FILE
HDD-CD-ROM, FDD, K/B, GLIDE, MIO, RTC/CF
P/C NUMBER

設計 87.8.19 機密文件
PIC AMBER
Garnet audio board M27 Cores
Size DOCUMENT NUMBER
240075C.504 (FOR VER.0.4)
REV

FILE NUMBER	DC-OC /IF	REV	D-5
Size Document Number		DCZIF SCH C PCB VERSION :	
Q

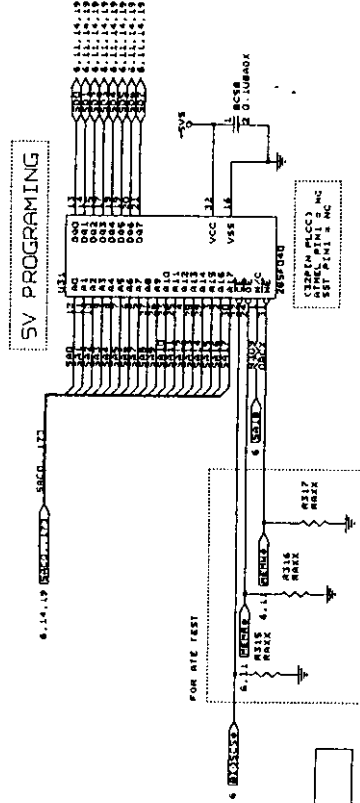
REV. 3.43) REV. 4
7/3 CANCEL 170 THEN CHANGE
TO 200A

LED STATUS

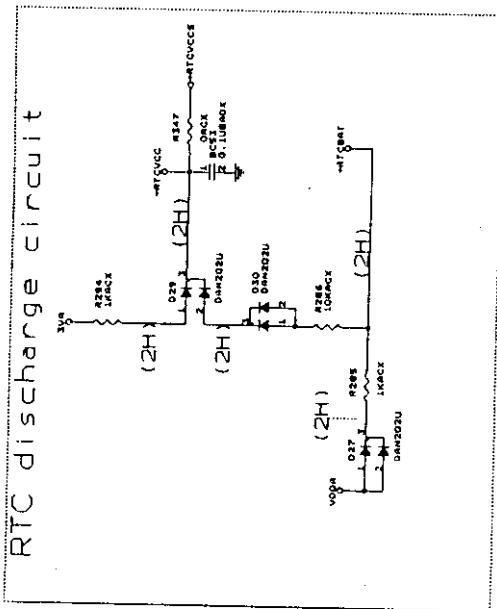
REV. 0.4 AND REV. 0.5
8/2 800 834703 THEN CONNECT TO -RTCVCCS

REV.0.4 REV.0.5
0/2 OUT DEXIS TRACE

PIC AMBER	
	VGA CRT CONNECTOR	
	Issue Document Number:	REV

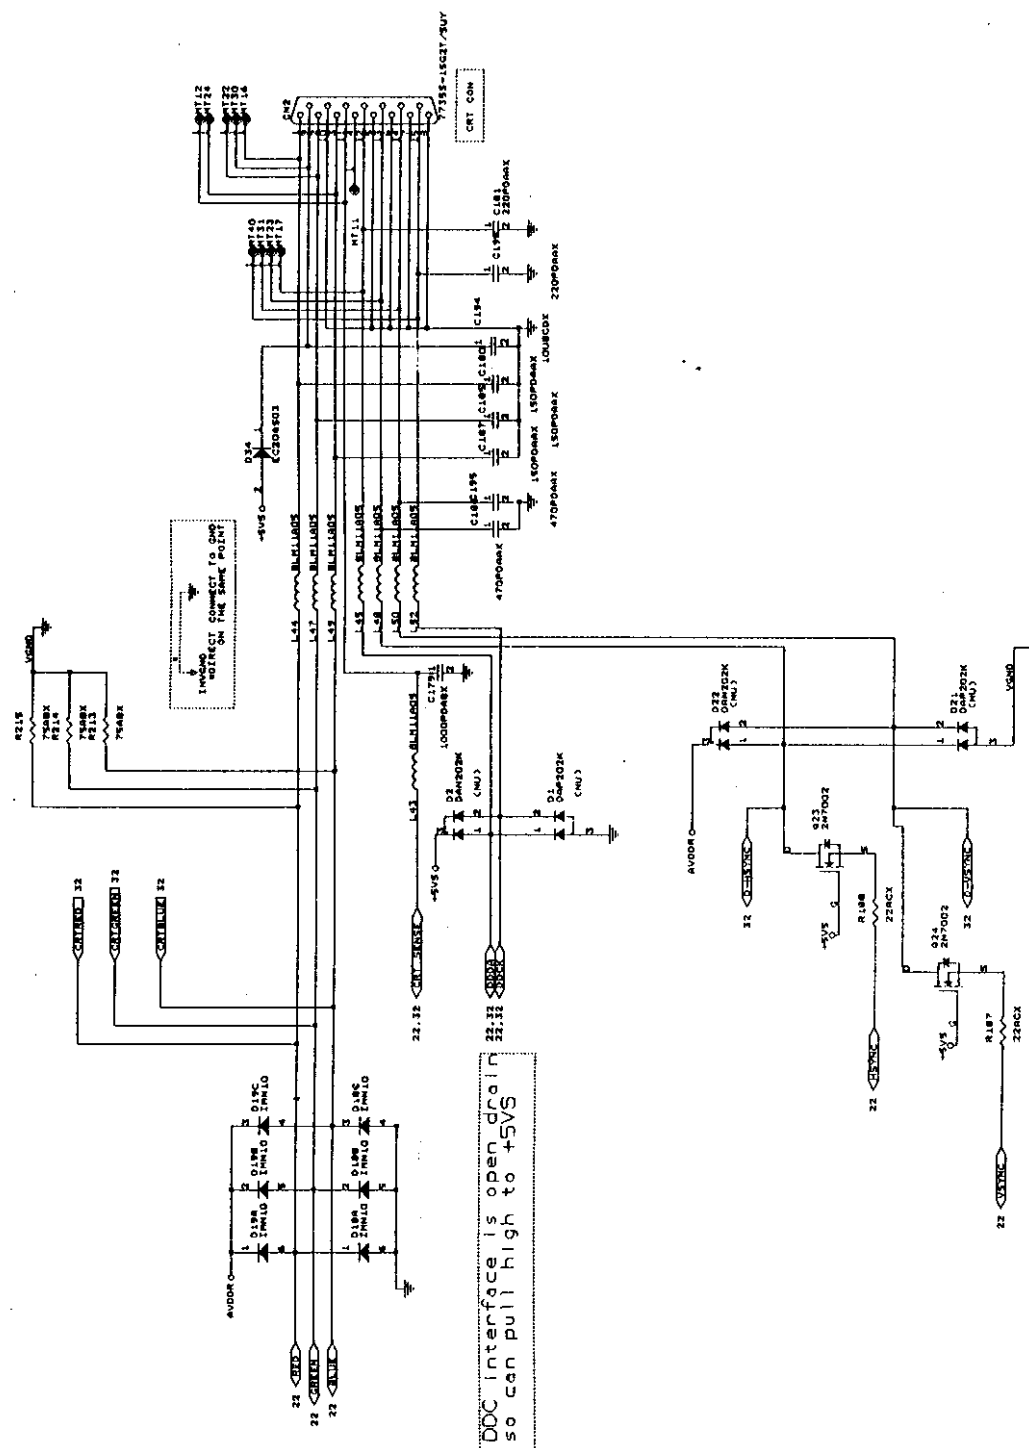
REV. O. 4 22> REV. O. 5
1/2 PL CHANGE TO 034<EC204503>

PIC NUMBER	MOESTRO 2
FILE	
REVISION NUMBER	
DATE

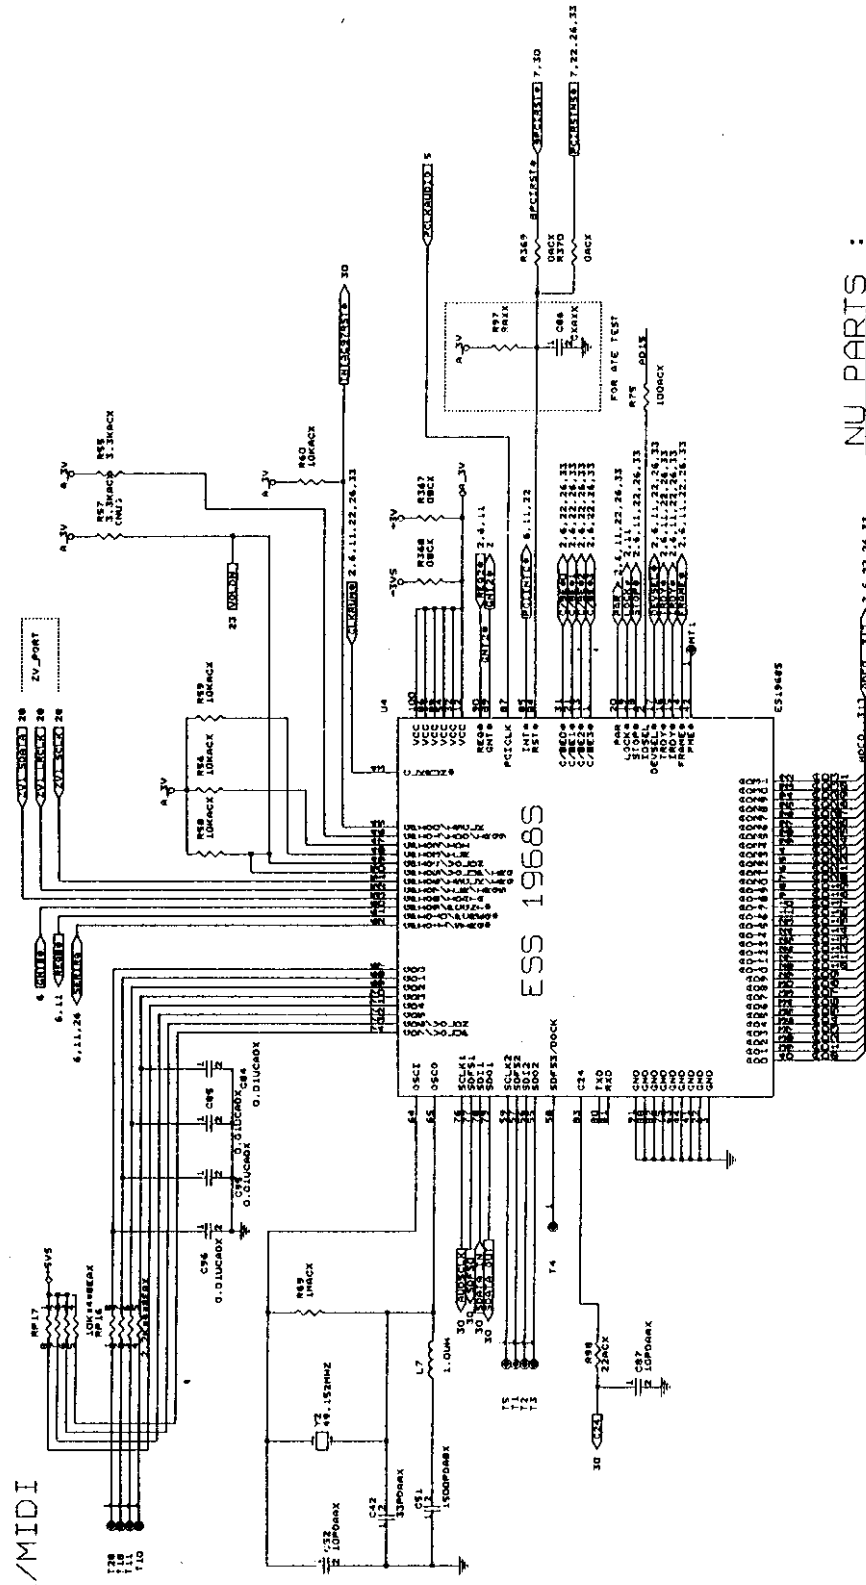
REV. 0.1 REV. 0.2 MODIFICATION
 6/1 V2 CHANGE TYPE THEN CANCEL RT4,RT5
 REV.0.4 REV.0.5
 8/2 RT5 CHANGE TO NU PART
 8/2 R97,R98,R99,R97,R98,R99,LOC100...1,R97 CONNECT TO R23V
 8/2 LOC100...1 ADD R338,R337 TO -3VS,-3V
 8/2 LOC100...1 ADD R338,R337 TO -3VS,-3V
 8/2 LOC100...1 ADD R338,R337 TO -3VS,-3V
 8/2 LOC100...1 ADD R338,R337 TO -3VS,-3V

REV. 2 -> REV. 3
6/17 HOOPNR ADD R346, R348 22K
REV. 0.4 383 REV. 0.5

ESS AUDIO

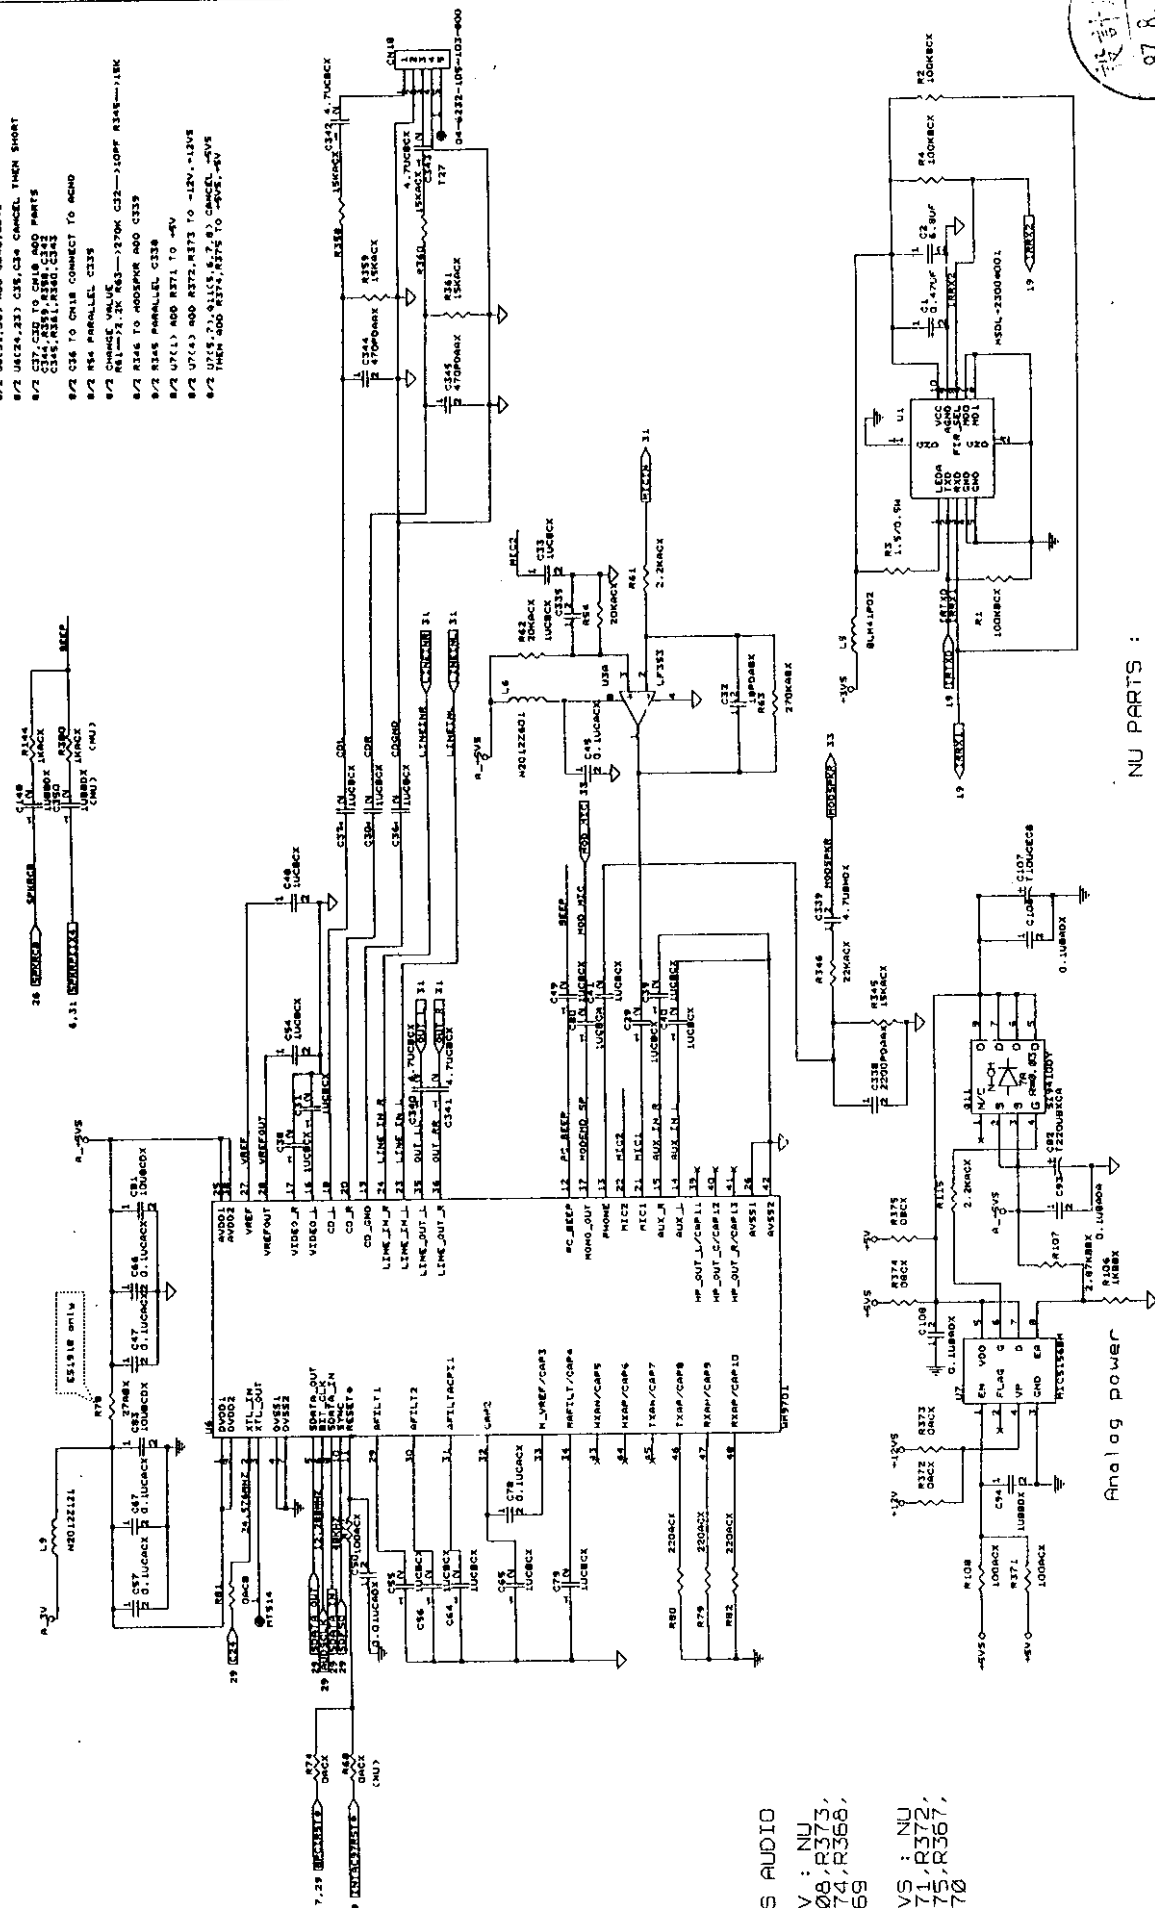
6/2 C350, R380 CHANGE TO NU PARTS
6/2 L9 CONNECT TO A-3V
6/2 C59, C58, R73, Y1 CANCEL
6/2 U63N, 361 ADD C340, C341
6/2 U63N, 361 C35, C36 CANCEL THEN SHORT
C34, C39, R381, R382 PARTS
C345, R381, R380, C343
6/2 C36 TO CN18 CONNECT TO ACHO
L985X (NU)
6/2 R54 PARALLEL C335
6/2 CHANGE VALUE
R81 -> 2.2K R63 -> 270K C32 -> 100PF R346 -> 15K
6/2 R346 TO HOOPNR ADD C339
6/2 R346 PARALLEL C339
6/2 U7(1) ADD R371 TO -12V, -12V5
6/2 U7(4) ADD R372, R373 TO -12V, -12V5
6/2 U7(5, 7, 8) CANCEL -4V5
THEN ADD R374, R375 TO -4V5, -4V

MODEM/LAN
CONNECTOR

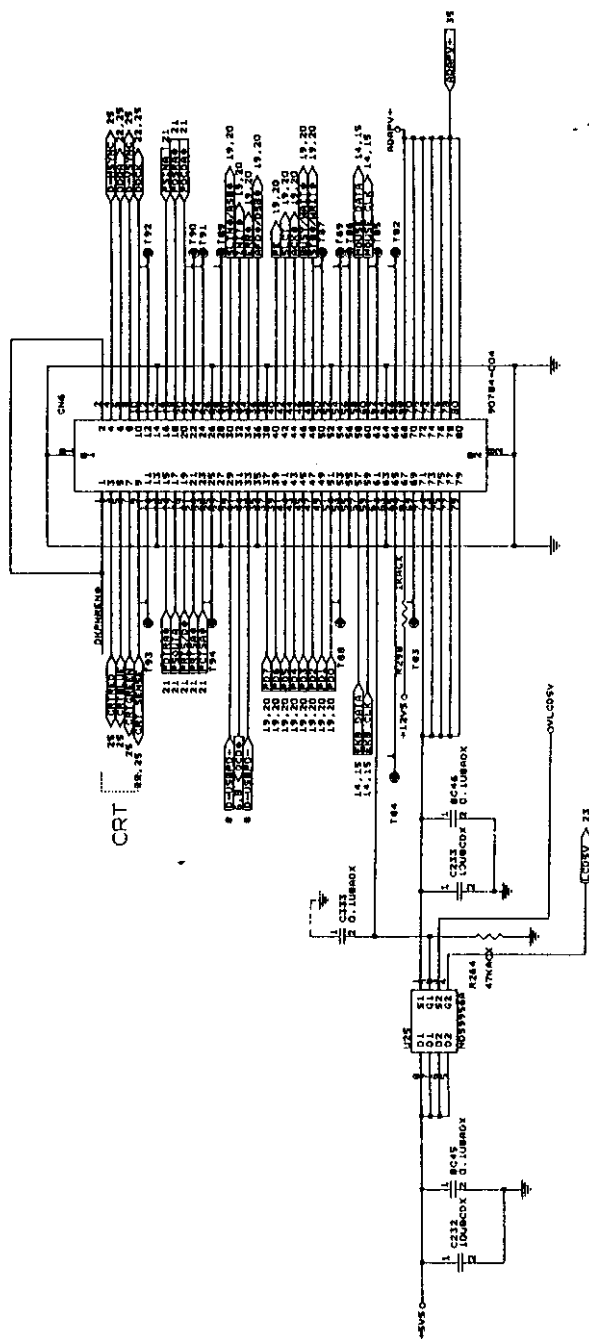
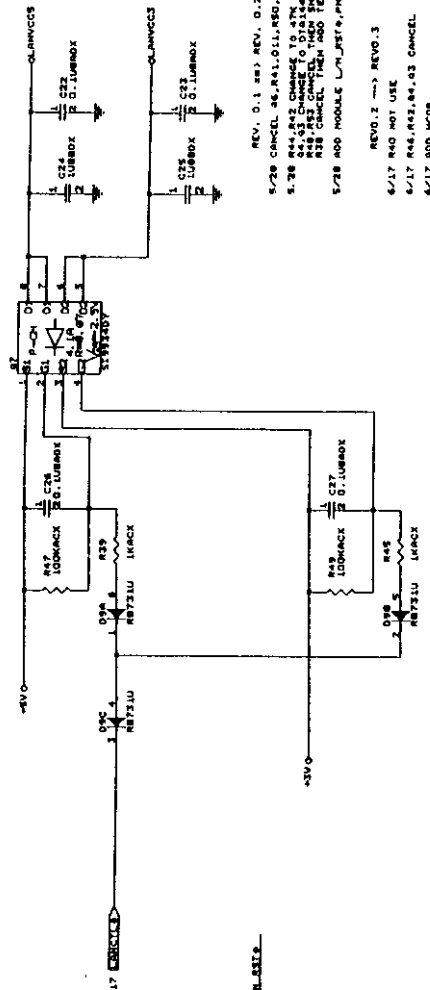
5/17 U25 P1A2 000 0.1UF TO GND

5/17 U25 P1A3 CHANGE TO VLCD5V

U25 P1A4 CHANGE TO LCD5V

5/17 GND P1N7 L.73, 75, 77, 79 SHORT

5/20 CANCEL 36,R41,011,R50,R52,010B,05 R43,U2

5 20 R44,R42 CANCEL TO 47M

04 93 CANCEL TO 074100M

R48 R43 CANCEL THEN SHORT

R38 CANCEL THEN ADD TEST POINT R170,M171

5/28 ADD MODULE W4,R57a,P4C8

REVO.2 --> REVO.3
6/17 R40 NOT USE
6/17 R46,R47,R48 CANCEL
6/17 ADD MCOB

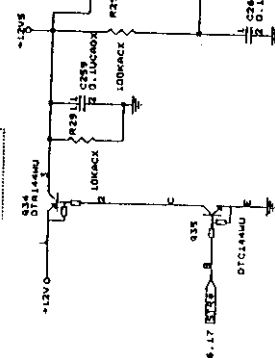
072 936(4) 800 R378.C349 THEN C349 IS MU PARTY

4/17 CH16 P1MZ.3 SHORT
4/17 CH15.C126 CHANGE TO 11000CA
